Re: Application for modification to McGill Environmental Systems Permit SWC-19-06

McGill Environmental Systems of NC, Inc. requests a modification to the above permit related to replacement and upgrade of the McGill-Merry Oaks building roof structure, air handling volumes and materials storage.

Appendix B – Drawing of Merry Oaks reconstruction

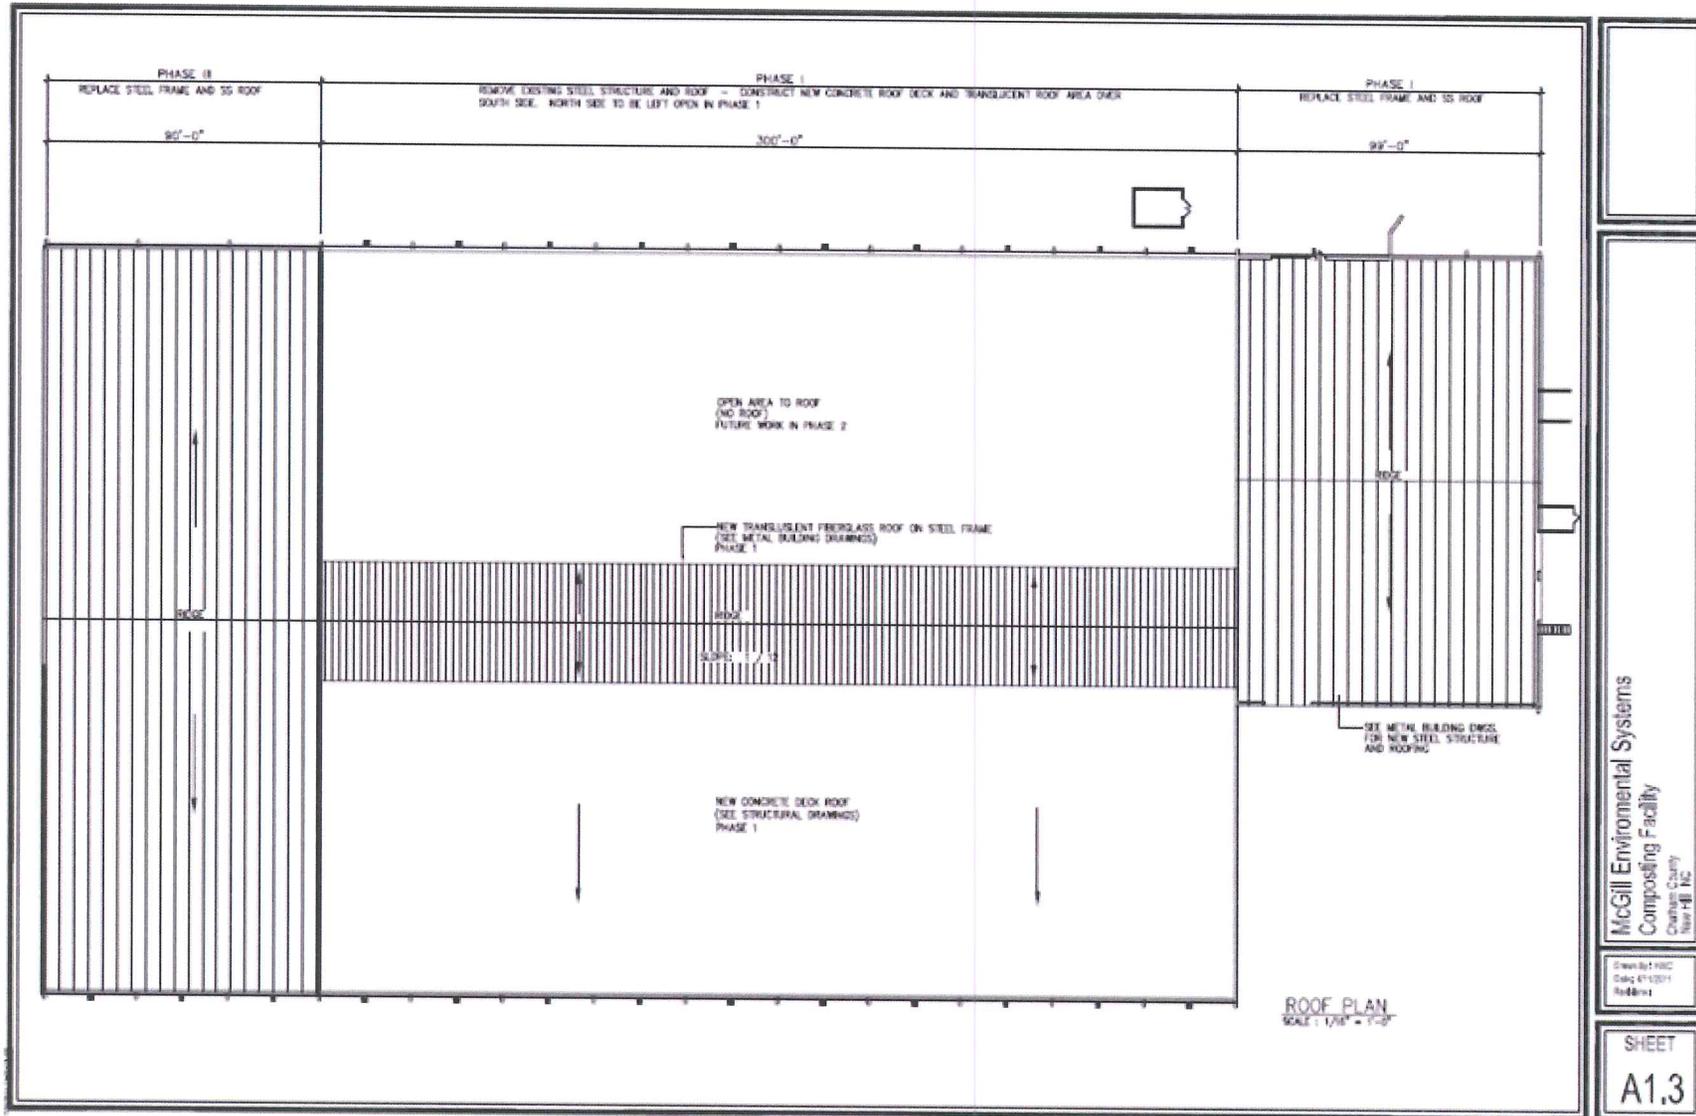
Upgrades are to be performed in three distinct phases. A color-coded drawing that illustrates these phases is attached as Appendix B.

This phase involves replacement of the roof over even-numbered bays. Future use of this portion of the building is being evaluated. This area is not being used for processing and has not been since the commencement of Phase 1.

- A. Return to production similar to odd-numbered bays
- B. Leave uncovered and use for storage of compost and amendments
- C. Use for covered storage and screening

At this time we request option B.

In this phase, we would replace the roof over three curing bays and the screening building. However, since the existing roof is intact and continues to function as it always has, we do not anticipate having to do this until well into the future.
